LaSalle County Station, Units 1 and 2
Facility Operating License Nos. NPF-11 and NPF-18
NRC Docket Nos. 50-373 and 50-374

Subject: Additional Information Supporting the Request for a License Amendment
to Revise Local Power Range Monitor Calibration Frequency

Additional Information Supporting the Request for a License Amendment to Revise Local Power Range Monitor Calibration Frequency

Figure 1. LaSalle Station LPRM Decay Constant

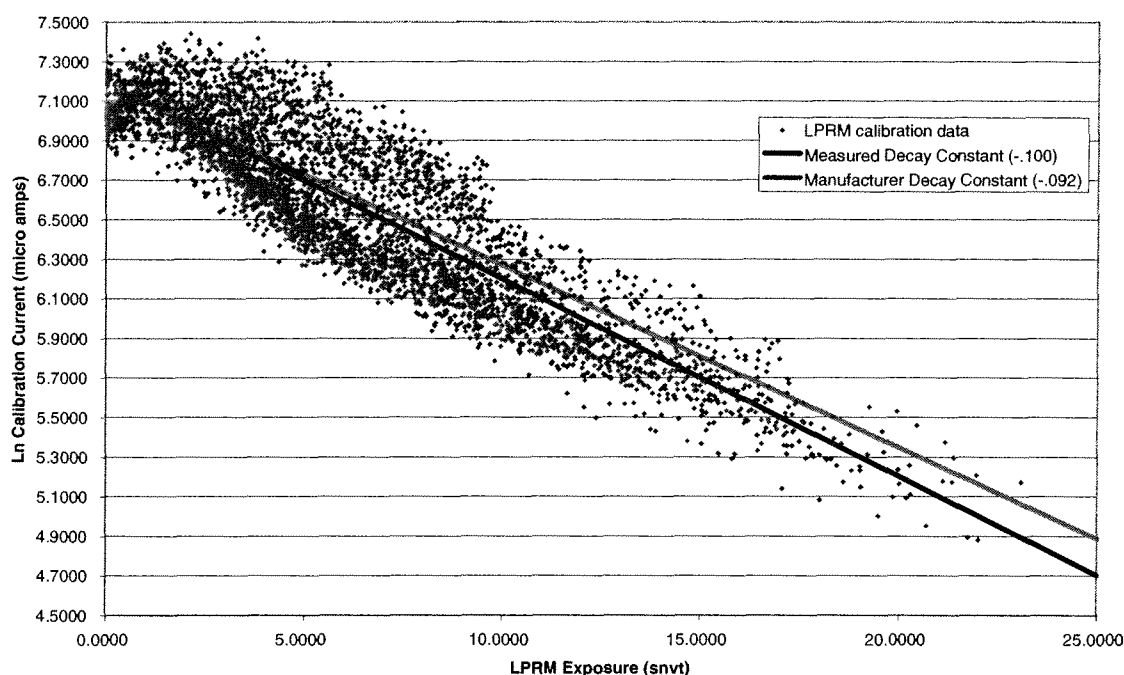
RAI-1 requested the licensee to provide an uncertainty analysis using decay constants specific to the LPRM detectors at the LSCS. The results should demonstrate that the uncertainties based on a fixed decay factor bound that based on the LPRM specific decay factors for the LSCS. In the response, the licensee did not provide the requested analysis. Instead, it summarized the results of its analysis and indicated that: (1) the analysis used in support of the LAR was based on a fixed decay factor of -0.092, which is based on manufacture's data; and (2) the decay constant used in the CMS will be adjusted to -0.100 to assure that the evaluated LPRM uncertainty is within the bounds of SLMCPR analysis.

With the results of the analysis with the fixed decay constants of either -0.092 or -0.100, the NRC staff is not sure whether the results are adequate to represent the actual data with values of the decay constants specific to various LPRM detectors at the LSCS. To resolve this RAI satisfactorily, the licensee should provide a discussion or an analysis (such as the requested detector specific decay constant analysis) to show that the assumption used in the analysis in support of the LAR is valid, i.e., the uncertainties based on a fixed decay factor bound that based on the LPRM specific decay factors for the LSCS. If the licensee uses an existing analysis to support the RAI response, it should address applicability of the existing analysis to the LAR. The RAI response should identify the effects of any plant specific deviations, such as the LPRM exposure data that may be collected from different models of LPRM detectors, or methods for the uncertainty analysis that may be based on different ranges of the LPRM exposures to represent a nominal exposure value.

LPRM calibration data for the NA-300 type LPRMs was collected for both LSCS Units 1 and 2 over a period of several years (Enclosure 1). During this time the core monitoring system (CMS) was accumulating LPRM exposure using the MICROBURN-B (1996 – 2004) or the MICROBURN-B2 (2004 – 2006) LPRM flux calculations. The core monitoring system evaluates the LPRM sensitivity between calibrations based upon this same LPRM flux calculation and a single input value for the variation in sensitivity as a function of LPRM fluence (i.e., exposure). In order to evaluate the uncertainty of this core monitoring system it is necessary to evaluate the variance in the actual and expected LPRM sensitivity. This is the analysis that was presented in the original License Amendment Request (LAR) and following Requests for Additional Information (RAIs). In order to project the uncertainty associated with longer calibration intervals, intermediate calibrations were ignored and the projected sensitivity is based upon the calibration one or more calibration steps previous. The projected sensitivity is based upon the single input value for the variation in sensitivity as a function of LPRM fluence. The measured calibration currents, provided in Enclosure 1, are compared to the vendor supplied logarithmic slope (i.e., -0.092) as well as the average slope determined from the measured data (i.e., -0.100) in Figure SRXB-1.1.

This collection of raw calibration currents is not representative of LPRM uncertainties since the LPRM is specifically calibrated for first use and the CMS uses this calibration to project the sensitivity during the interval between that calibration and the next

calibration. This projection is based upon a constant calibration current below a user defined breakpoint and a user defined logarithmic slope (i.e., decay constant). LSCS provides a single value for the breakpoint and slope for all NA-300 detectors. The error in the LPRM reading just prior to the next calibration is evaluated by comparing the measured calibration current with the projected calibration current at the time of a calibration.

A detailed discussion of the methodology was provided in Reference 1. The LSCS data described above and provided in Enclosure 1 supports using a fixed decay constant of -0.100 . This decay constant was used in the uncertainty analysis and supports the conclusions provided in Reference 1.
